**ADDENDUM NO. 1
TO CONTRACT DOCUMENTS FOR THE
COYOTE WAREHOUSE PROJECT
Project No. 91234002**

Contract No. C0635

Notice is hereby given to Prospective Bidders that the Contract Documents are modified as hereinafter set forth.

DETAIL C101 SITE LOGISTICS PLAN
SCALE: 1" = 60'-0"

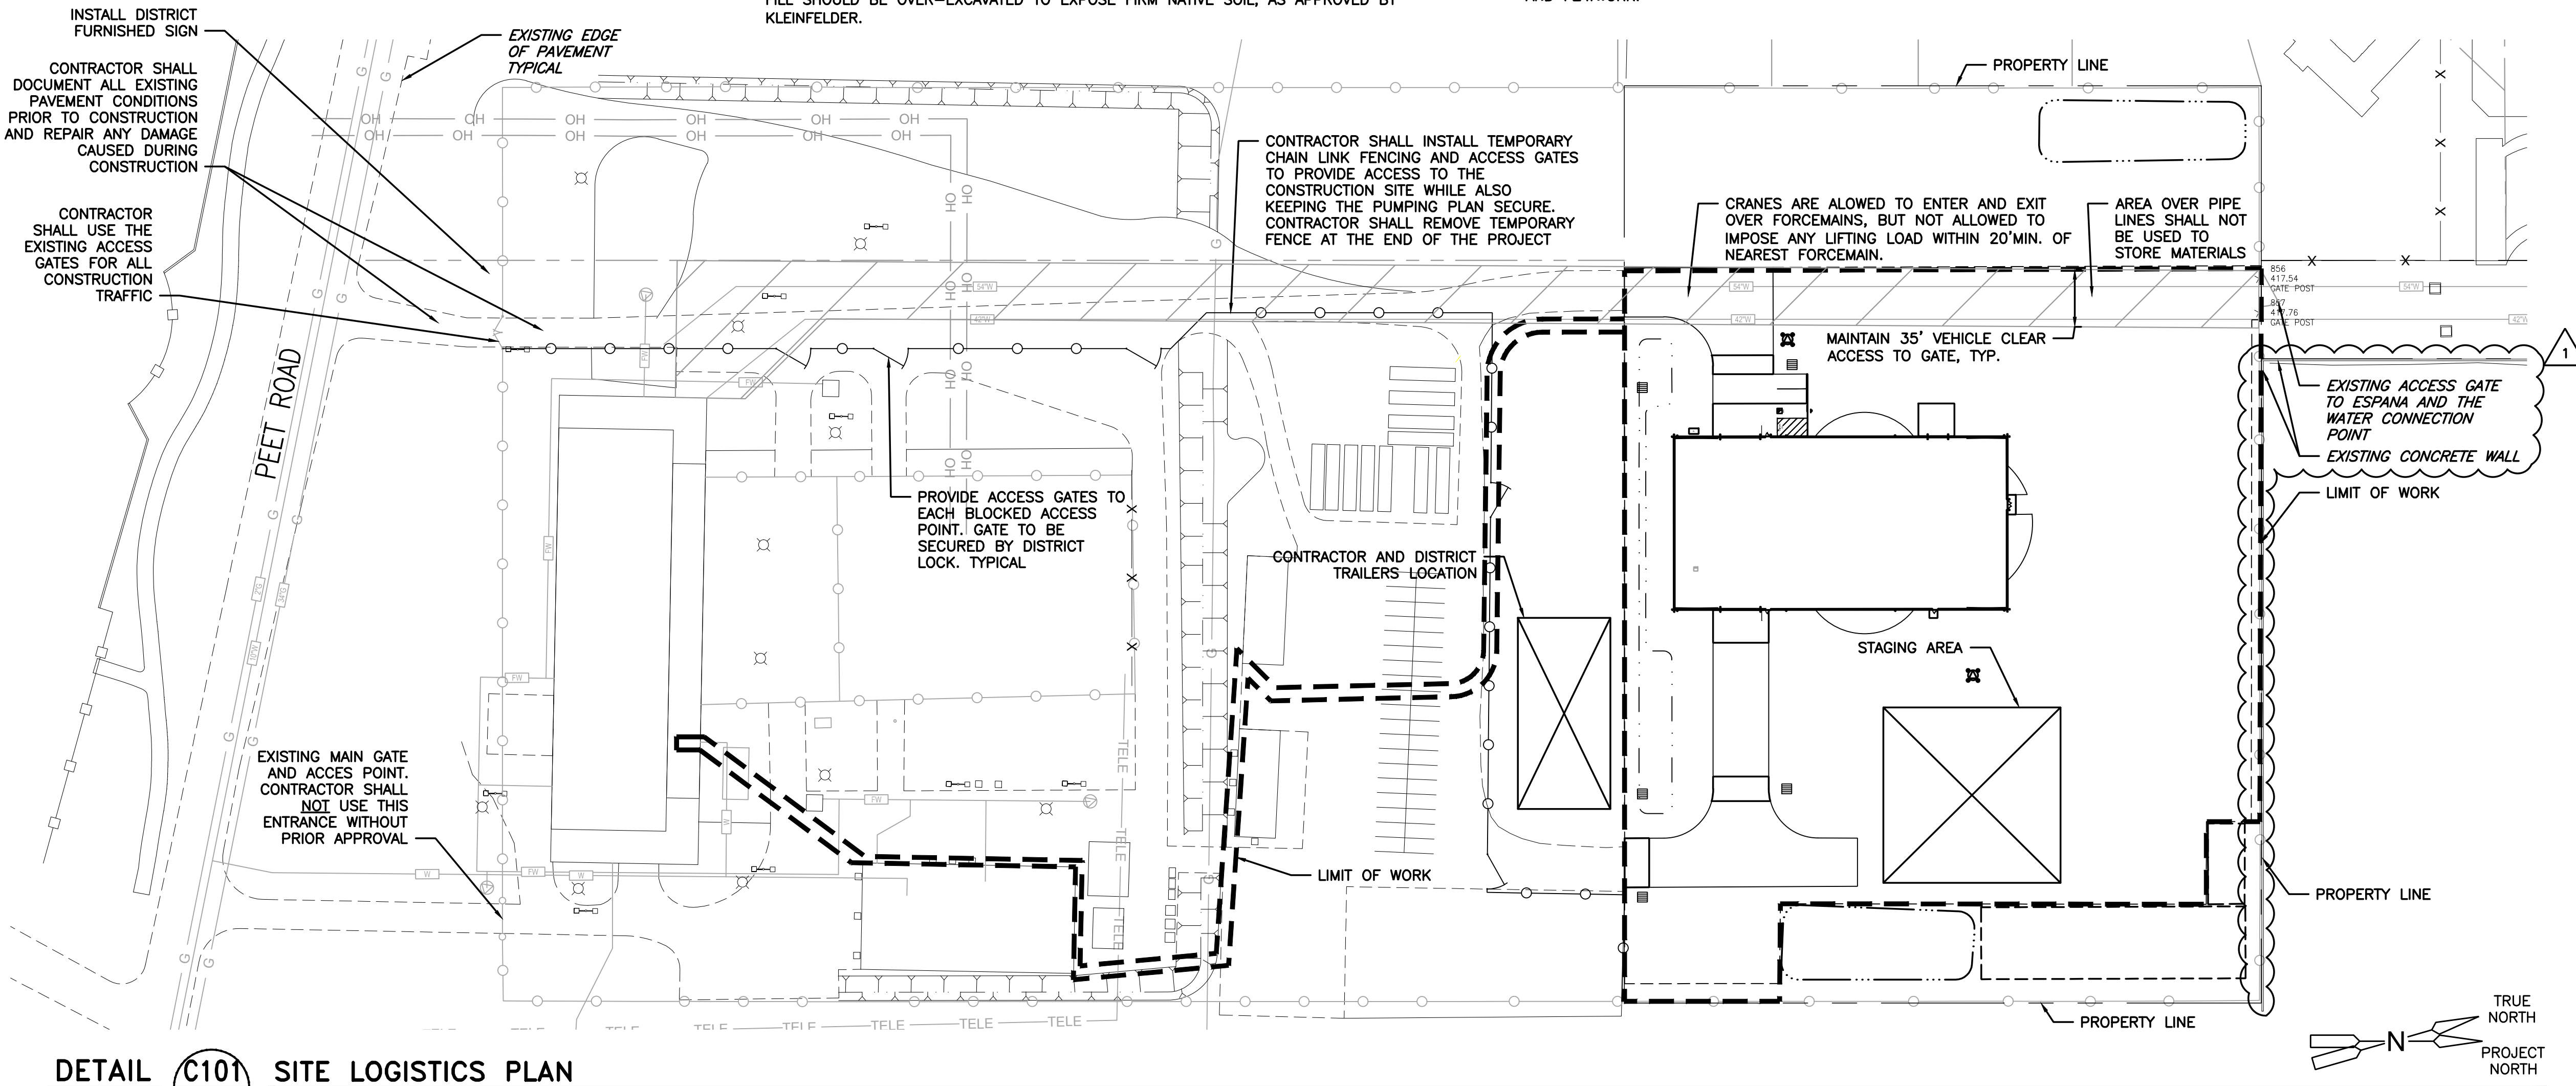
Item no.	Drawing No.	Description
D1-1	G-05	<u>REVISED</u> the symbol legend to accurately reflect the various materials represented throughout the plan set.
D1-2	G-09	<u>ADD</u> the recently built concrete wall on the north side of the project to the background
D1-3	G-10	<u>ADD</u> the recently built concrete wall on the north side of the project to the background
D1-4	GD-1	<u>ADD</u> the recently built gravel lot and called for partial demolition as well as added the recently built concrete wall on the north side of the project to the background
D1-5	GD-1	<u>ADD</u> the removal of two shrubs at the northwest corner of the site
D1-6	GL-1	<u>REVISED</u> the irrigation legend, planting notes, and pipe sizing schedule
D1-7	L-01	<u>ADD</u> Detail of water point of connection was added and the line type of all irrigation lines were clarified.

DETAIL **C208** BIO-RETENTION BASIN
SCALE: N.T.S.

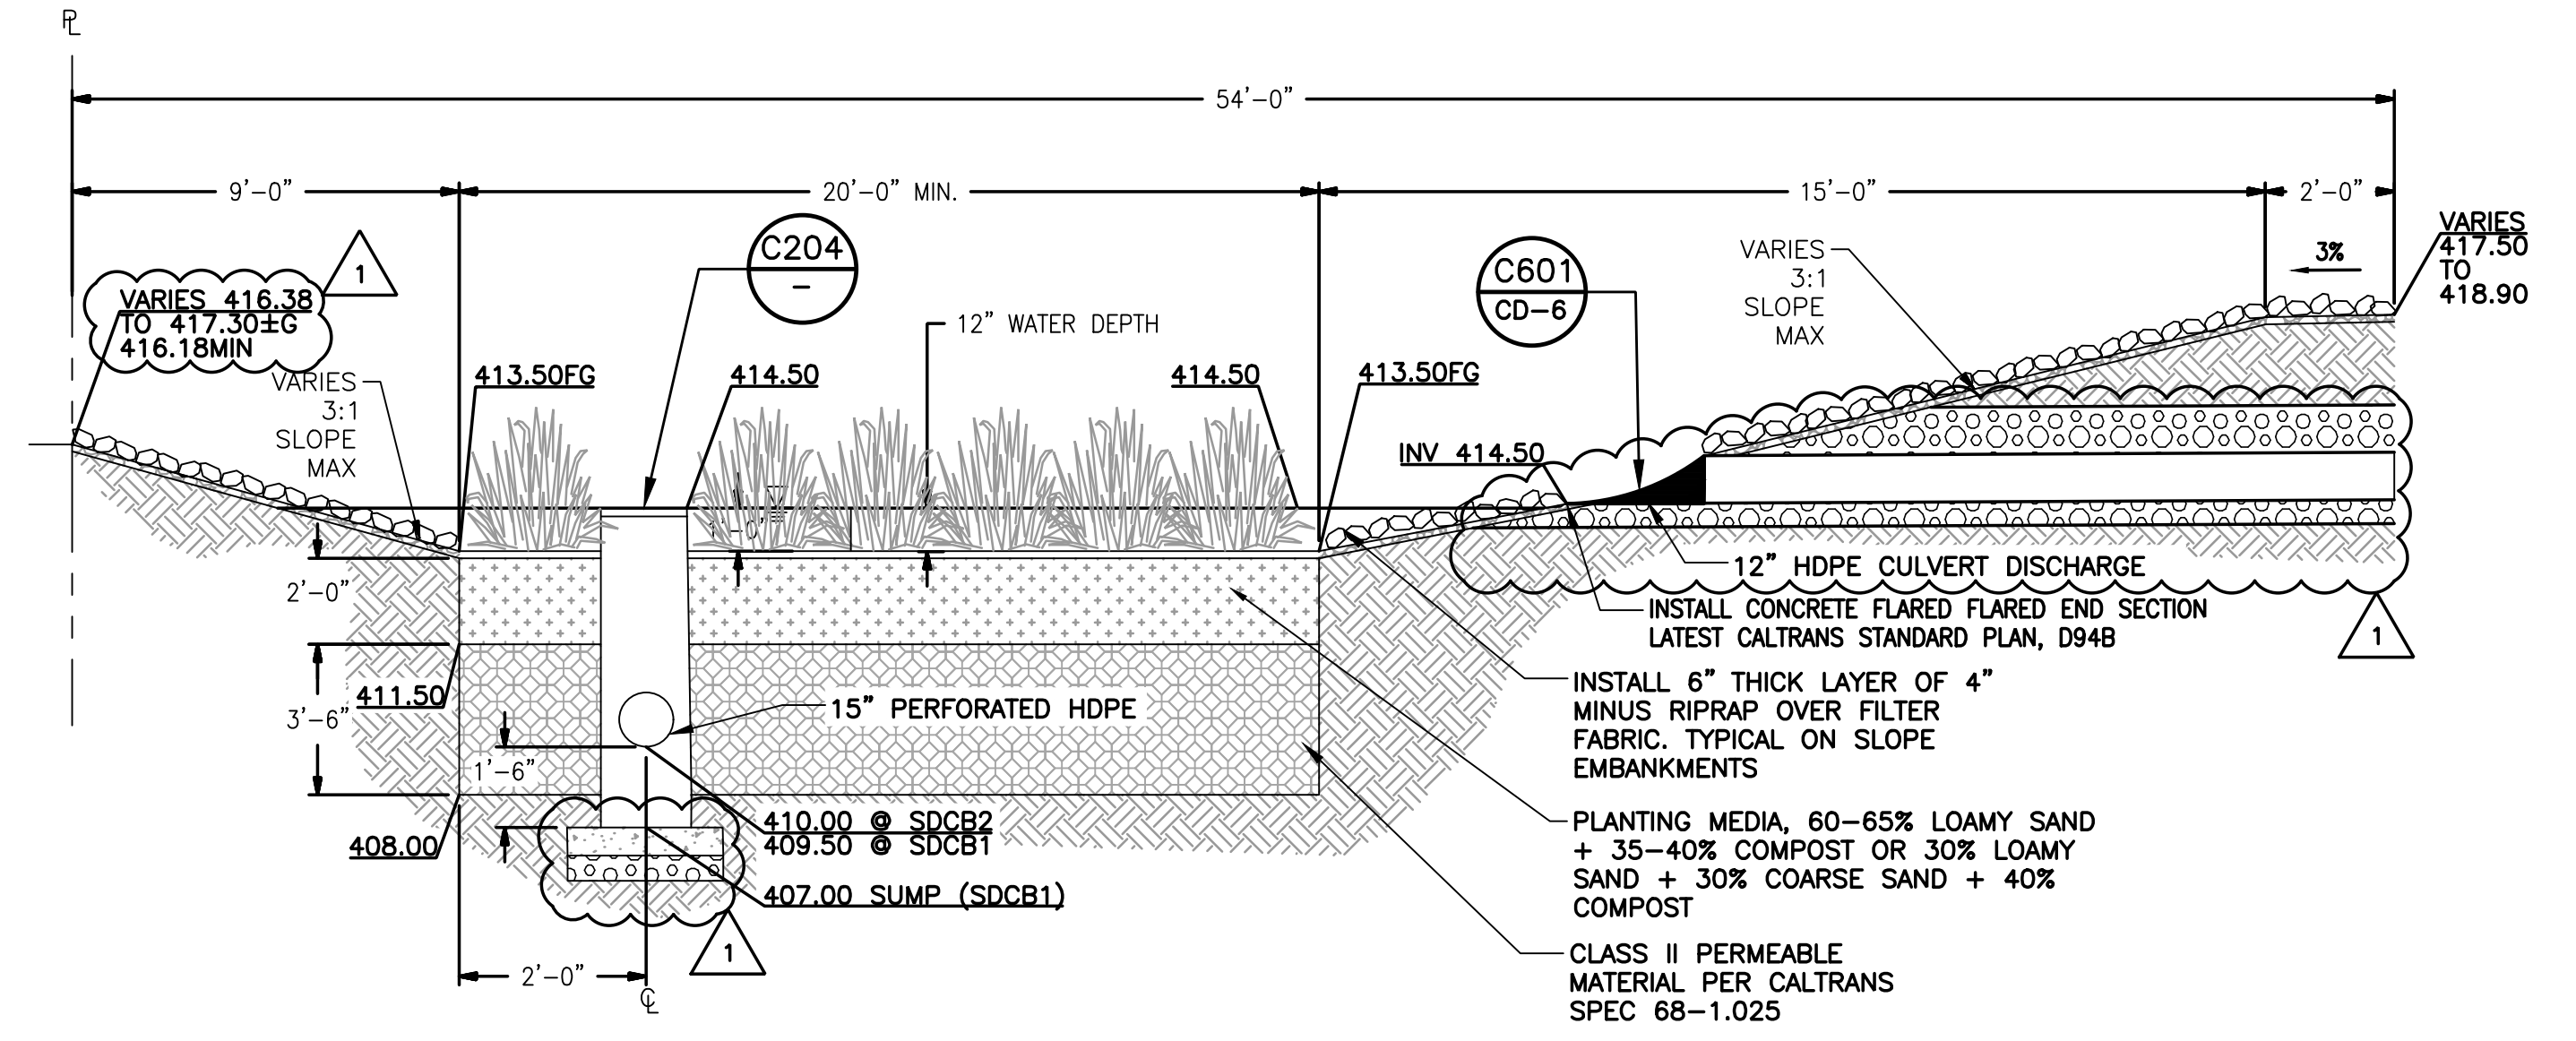
D1-15	CD-2	<u>ADD</u> material clarifications to match the plan symbology and legend and altered the elevations in details C207 and C208. See Attachment E.
D1-16	CD-3	<u>ADD</u> material clarifications to match the plan symbology and legend and altered the pipe material and rainwater leaders in details C301 and C302. See Attachment E.
D1-17	CD-4	<u>ADD</u> material clarifications to match the plan symbology and legend and altered the pipe material and rainwater leaders in details C401. See Attachment E.
D1-18	CD-5	<u>ADD</u> material clarifications to match the plan symbology and legend and altered the pipe material and rainwater leaders in details C501. See Attachment E.
D1-19	CD-6	<u>ADD</u> material clarifications to match the plan symbology and legend. See Attachment E.
D1-20	GA-02	<u>ADD</u> north concrete wall to plan background and updated the rock pile locations to match the rest of the plan set. See Attachment E.
